ADDENDUM NO. 01

February 14, 2024

**ZCS-ZCHS Stadium Locker Building & Concrete Repairs, ZMS Tennis Courts
and Eagle Elementary Building Demolition & Playground Renovation
1000 Mulberry St.
Zionsville, IN, 46077**

This Addendum consists of Pages ADD 1-1 through ADD 1 - 3 and attached Addendum No. 1 from Fanning Howey dated February 14, 2024 for **Zionsville High School 223139.00** consisting of 5 pages, specification section 10 14 23.16 – Interior Panel Signage, and 29 Drawings. **Eagle Elementary 223135.00** consisting of 1 page and 2 Drawings, and **Zionsville Middle School 223144.00** consisting of 1 page and 2 Drawings.

UNIT A - FIRST FLOOR ARCHITECTURAL PLAN

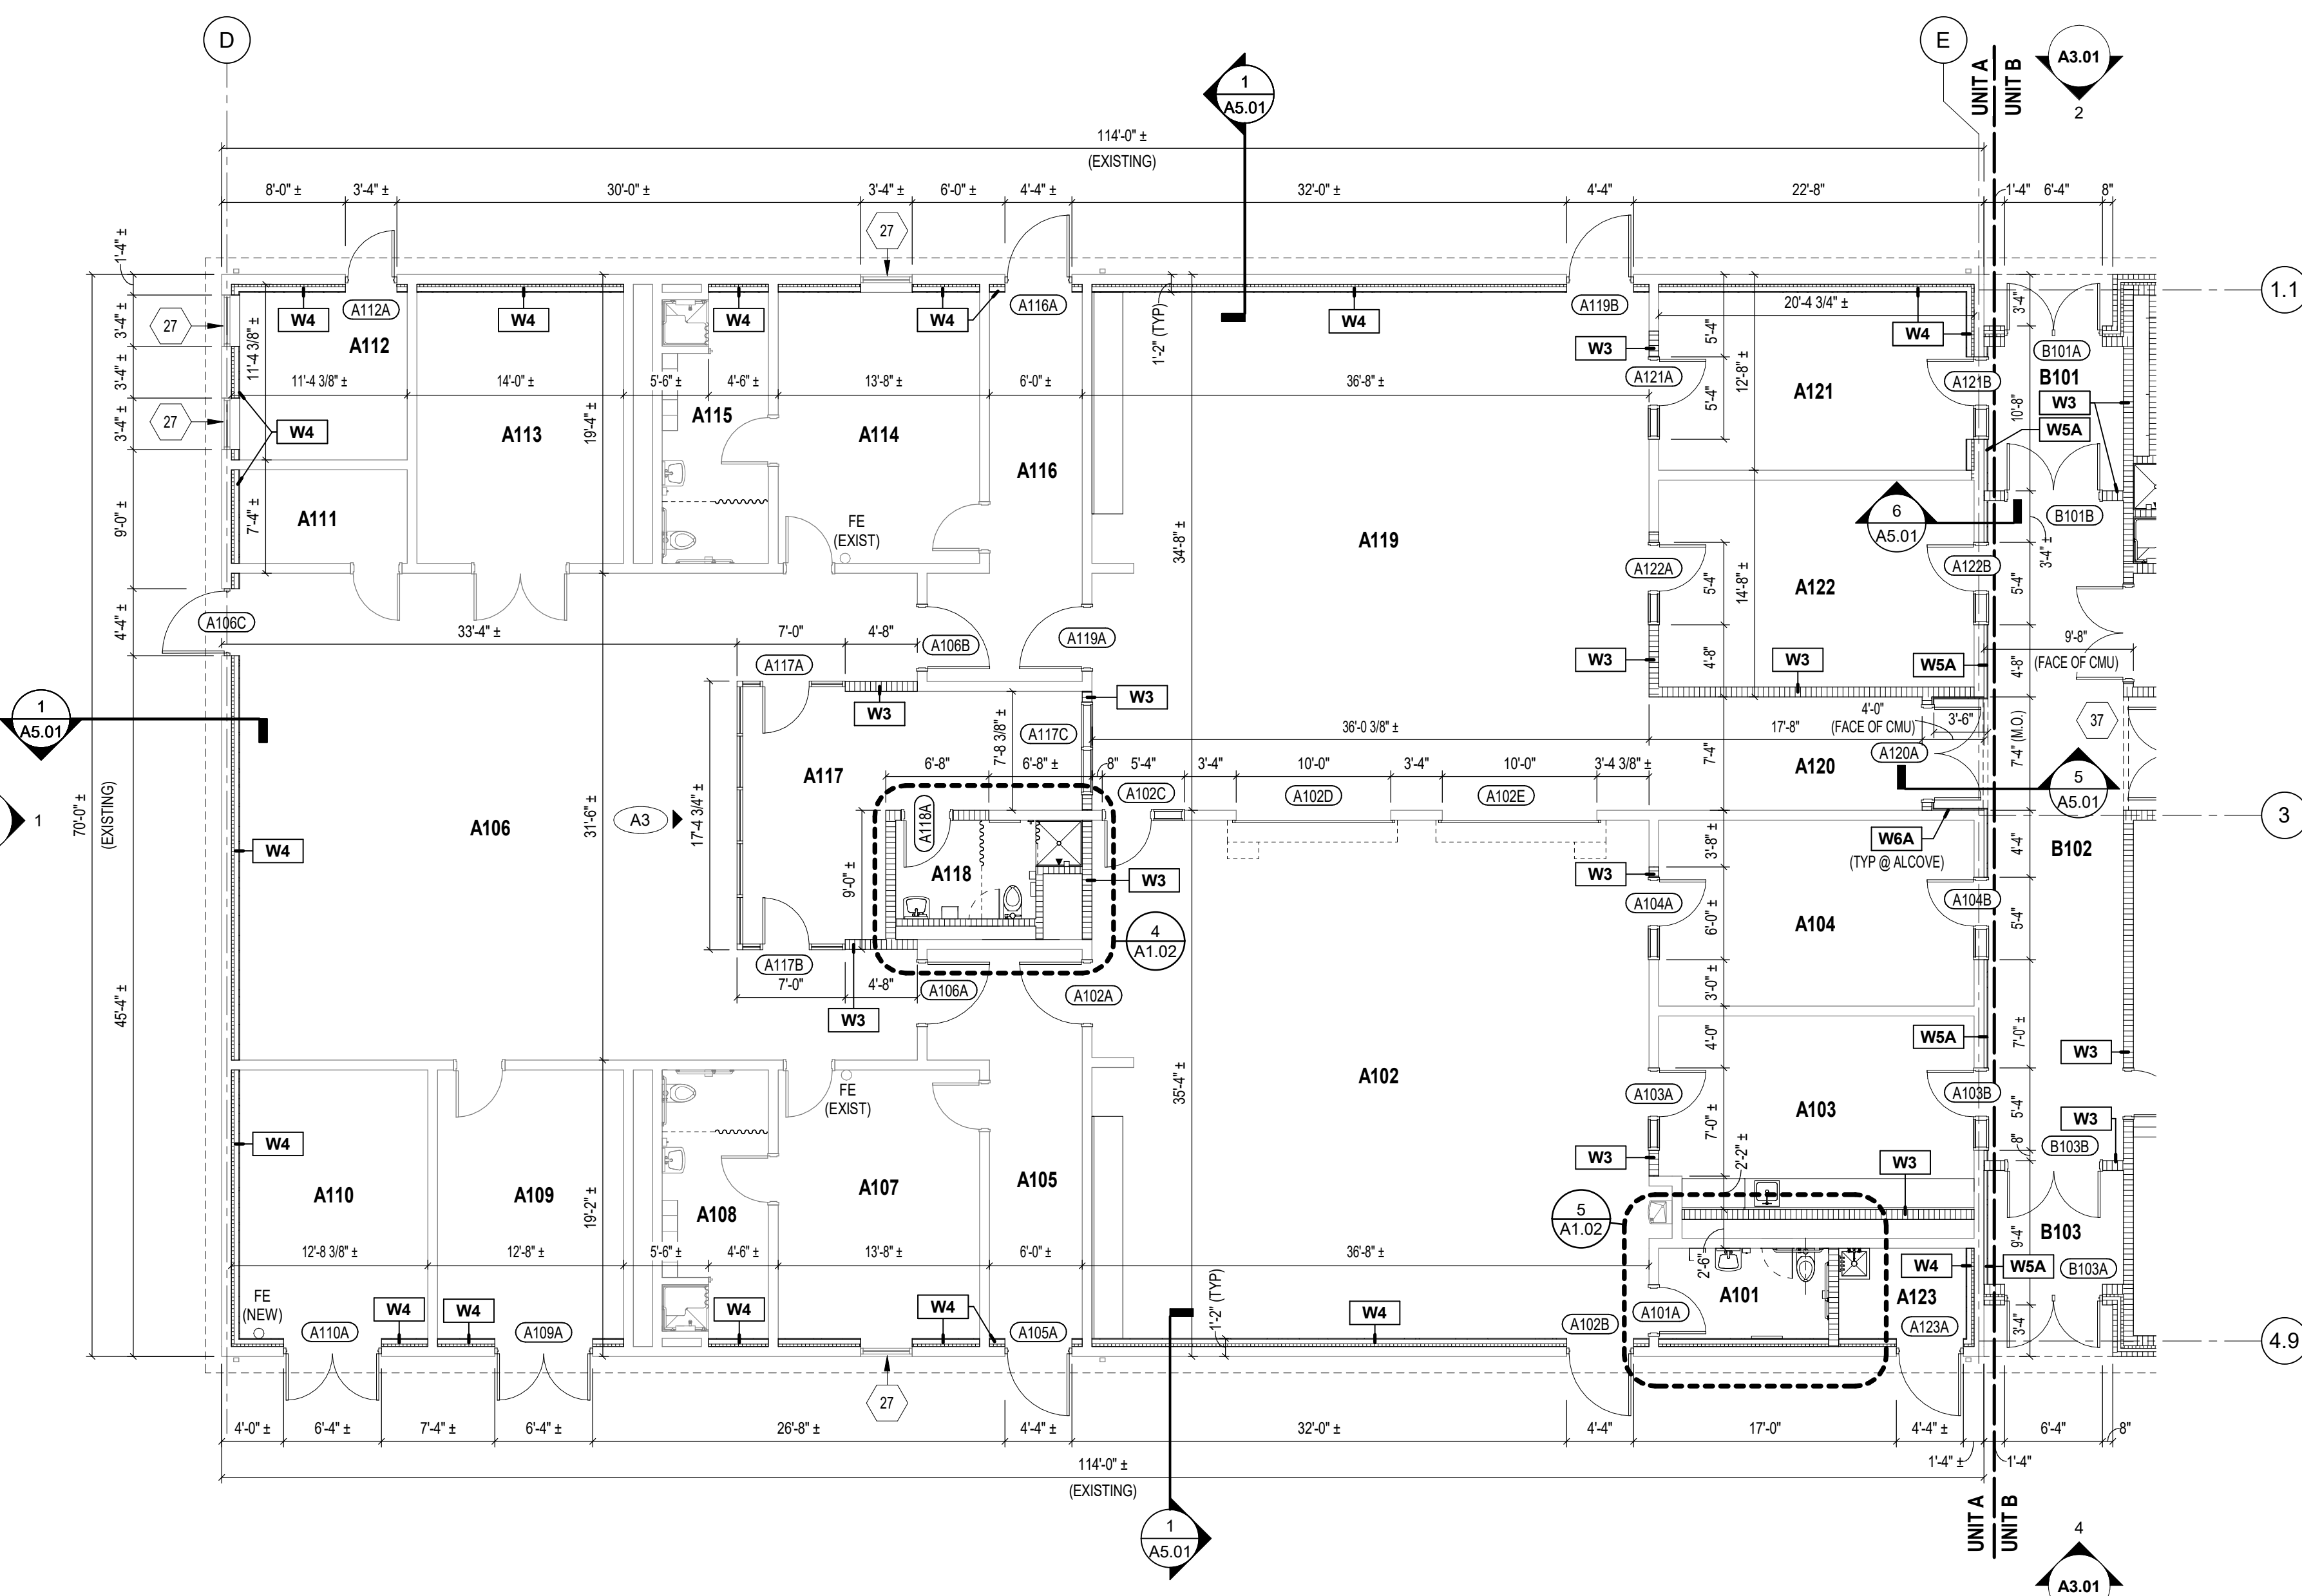
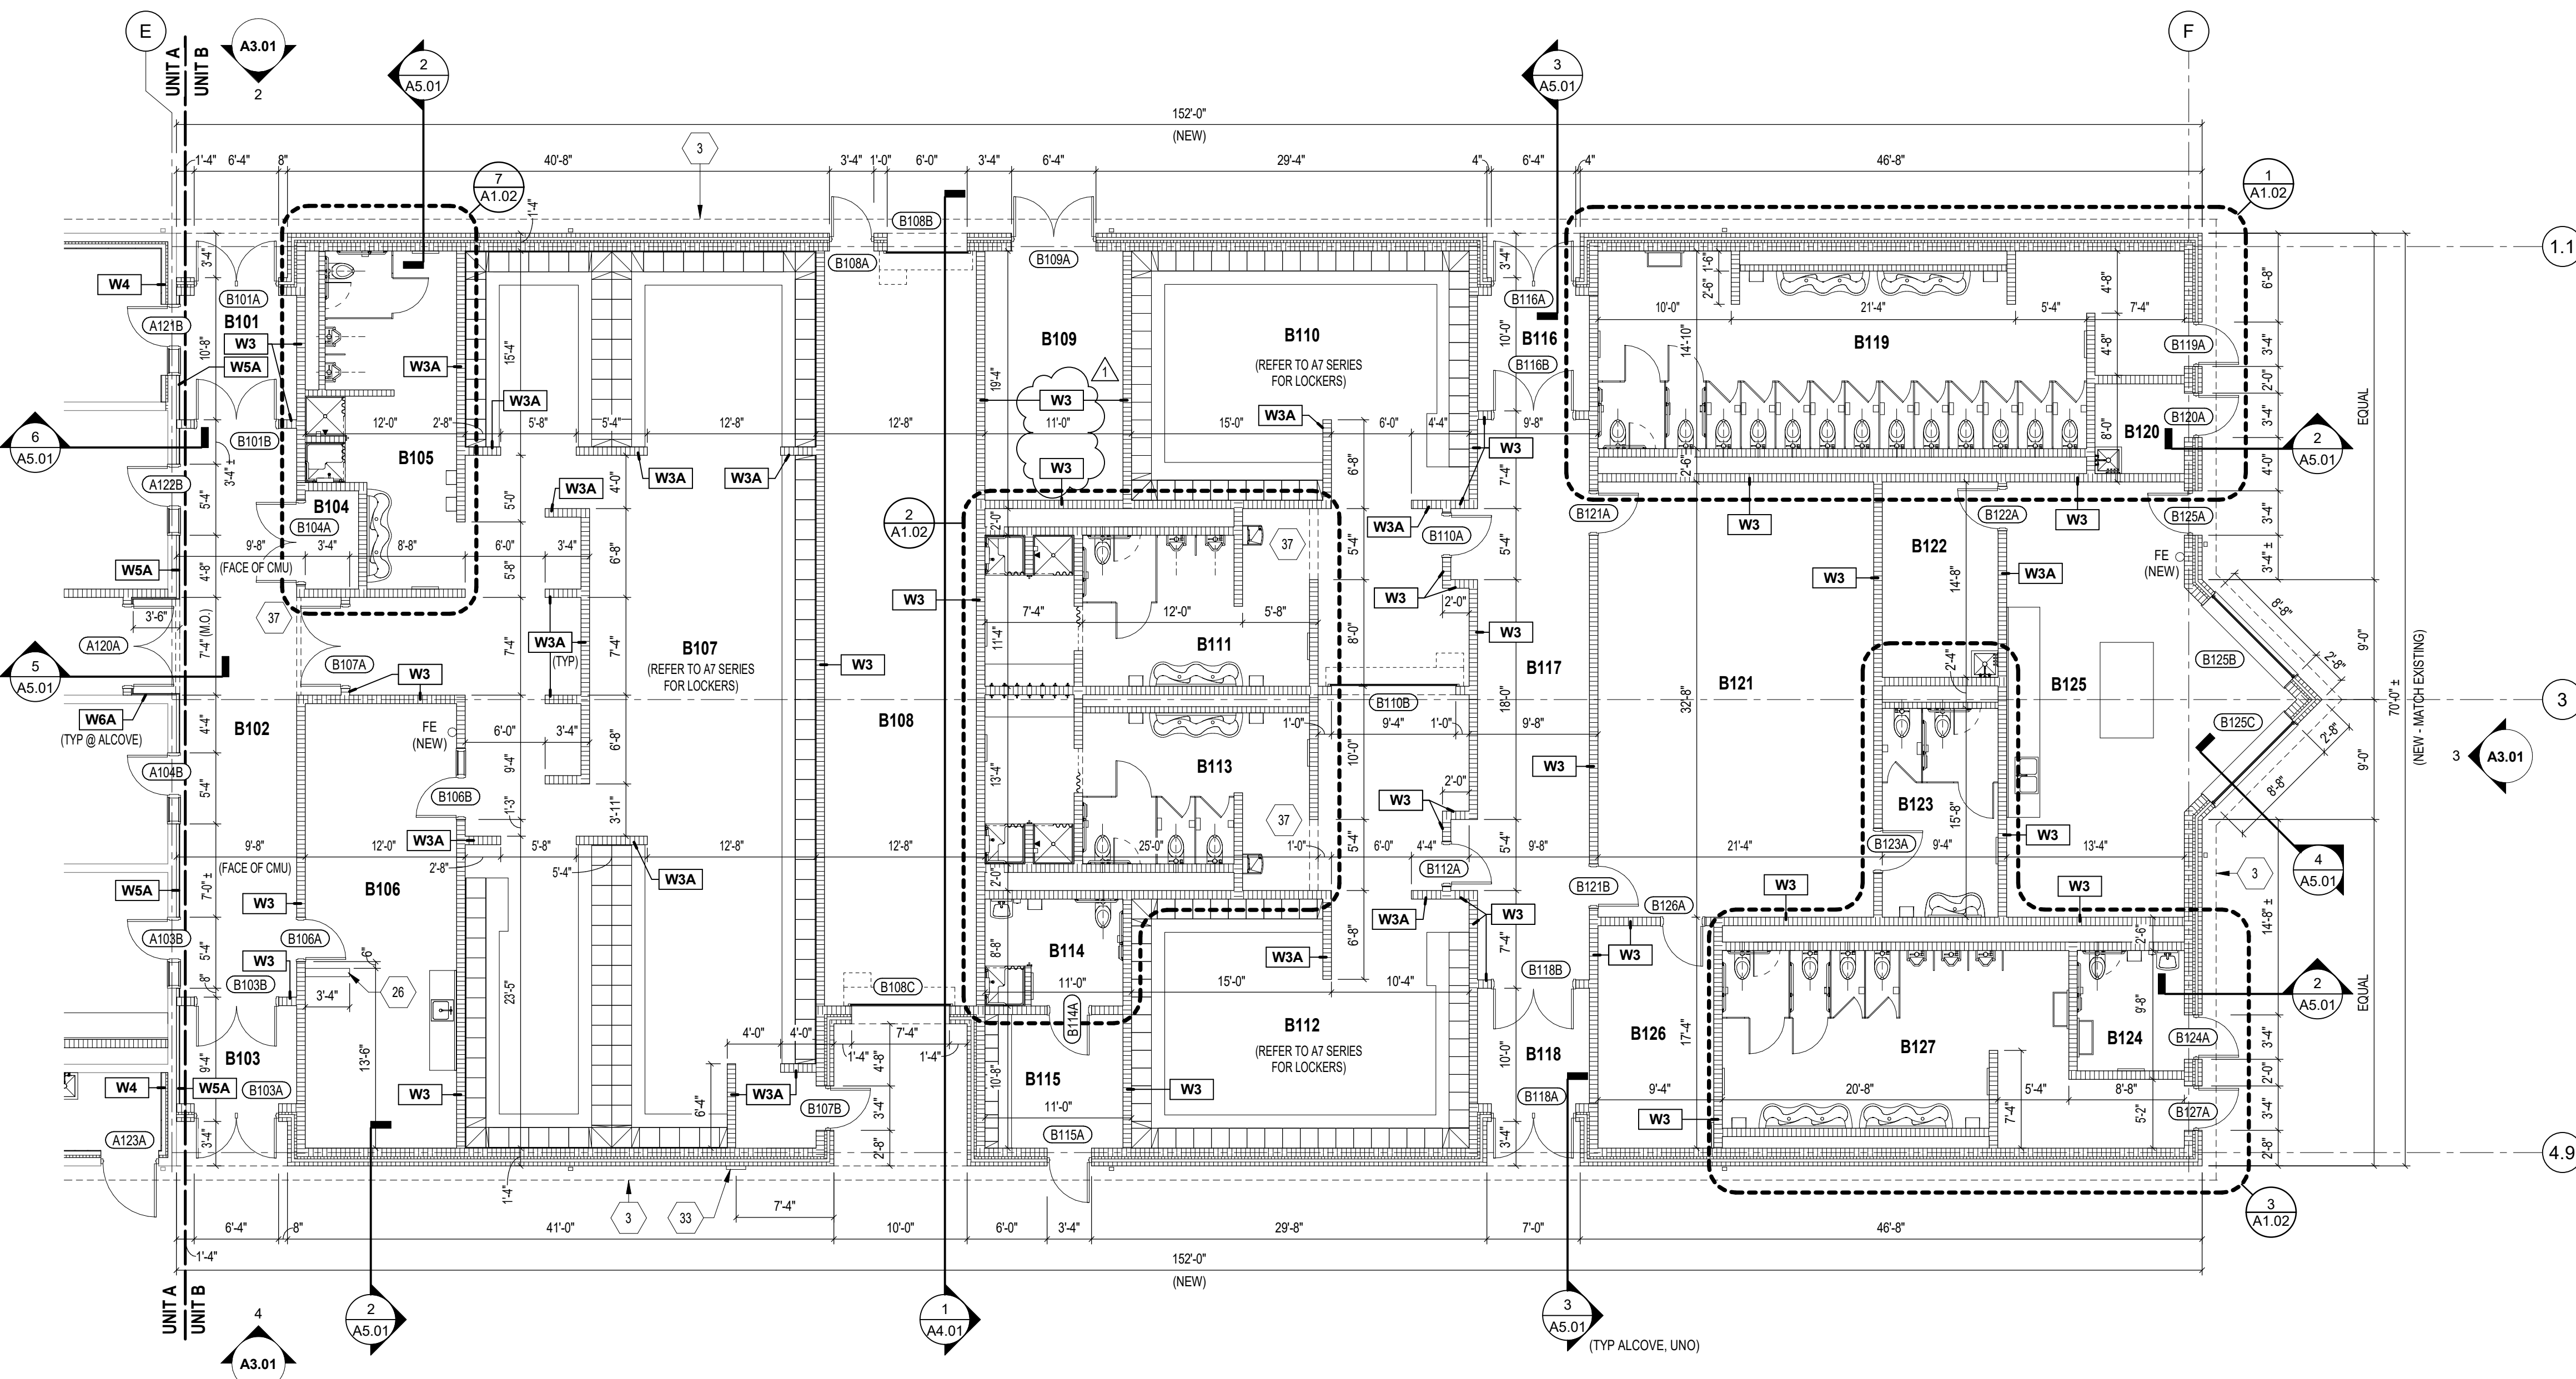
- A. Revise all "W4A" wall tags to read "W4", typical.

SITE DEMO PLAN

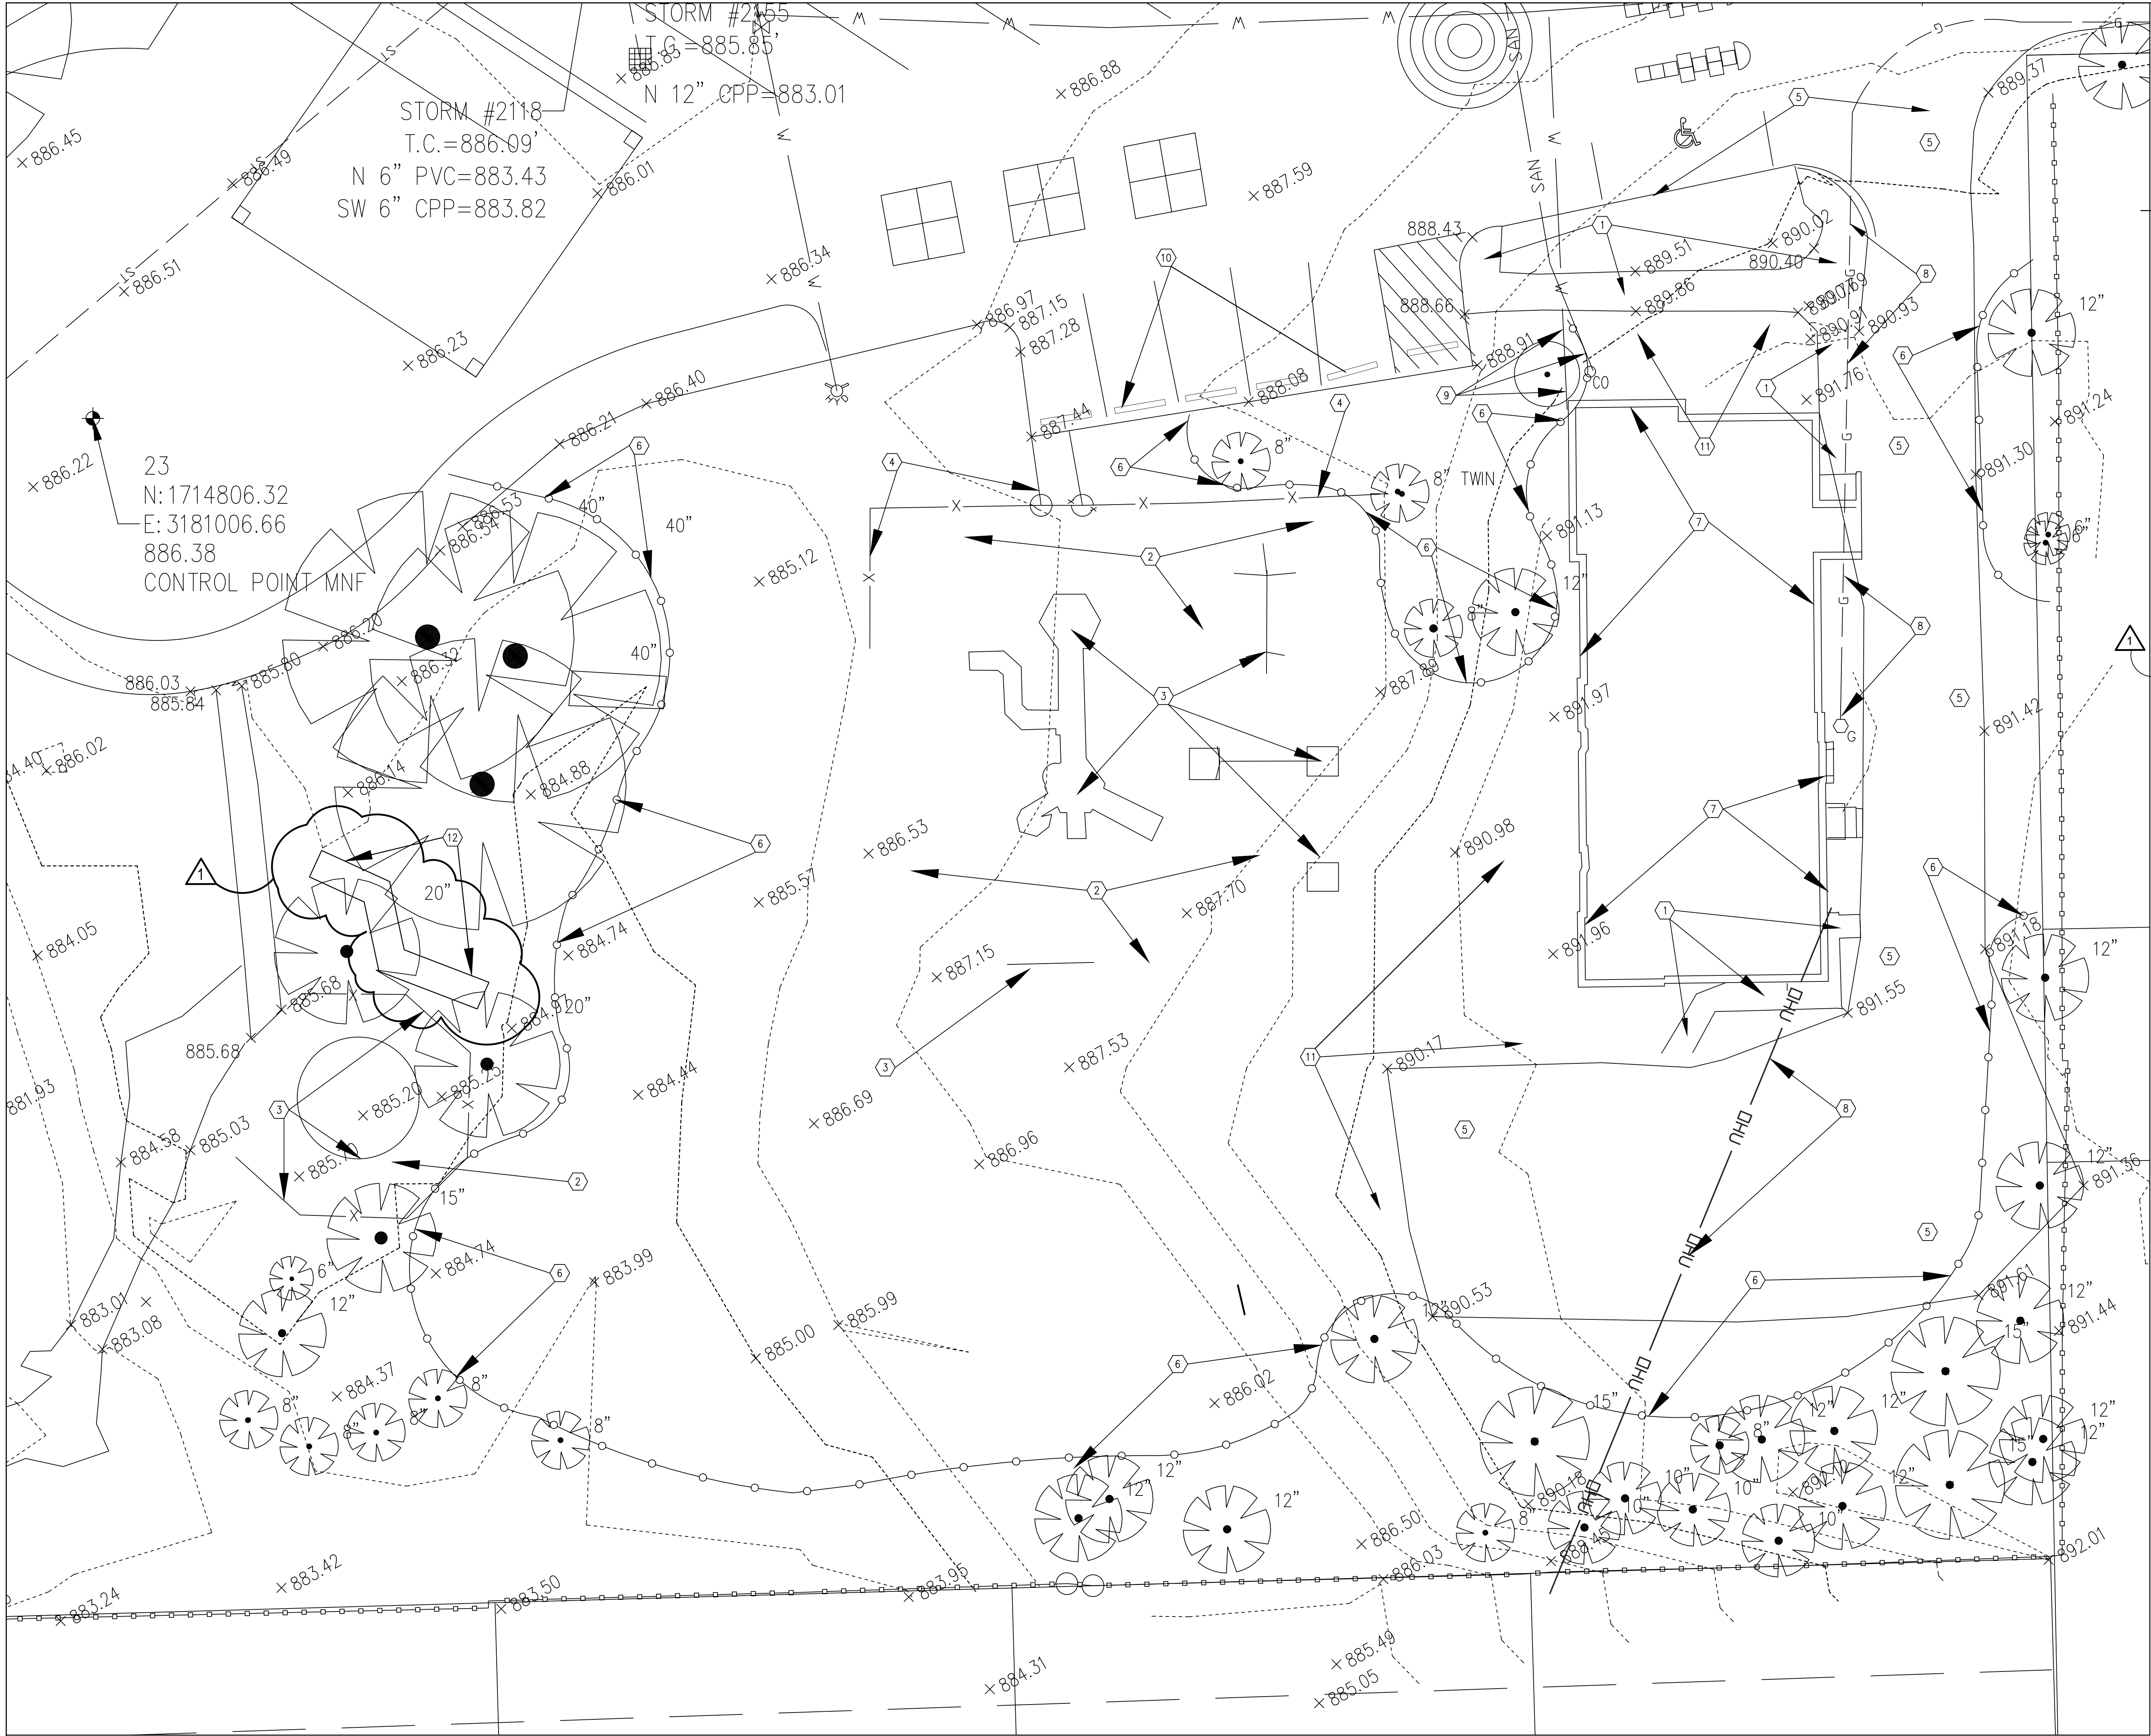
ITEM NO. 3. DRAWING SHEET NO. E2.01 - EAGLE ELEMENTARY ELECTRICAL SITE PLAN
